Product Change Notification / RMES-07BGQT464

CCB 5257 Initial Notice: Qualification of MMT as an additional assembly site for selected DSPIC33CK32Mx102 and DSPIC33CK64Mx102 device families available in 28L UQFN (4x4x0.6mm) package.

CCB 5257

**Pre and Post change comparison
PCN #: RMES-07BGQT464**

ASE

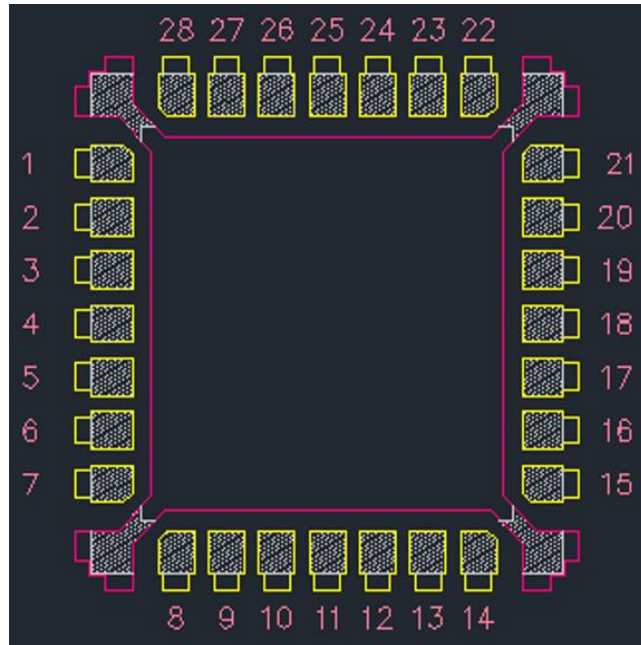
Pre and Post Change Summary – Lead frame comparison

| Lead-Frame Material | C7025 |
| Lead-lock (Locking Holes) | No |

MMT

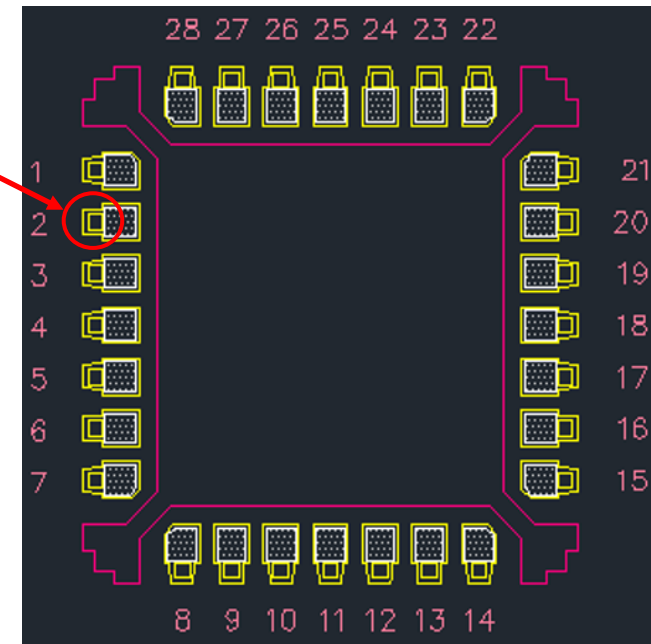
Lead-Lock
(Locking Holes)

| Lead-Frame Material | EFTEC64T |
| Lead-lock (Locking Holes) | Yes |

Note: Mold compound materials fills the lead lock holes, which provides improved protection against moisture penetration along the edge of the leads (pins) of the package.
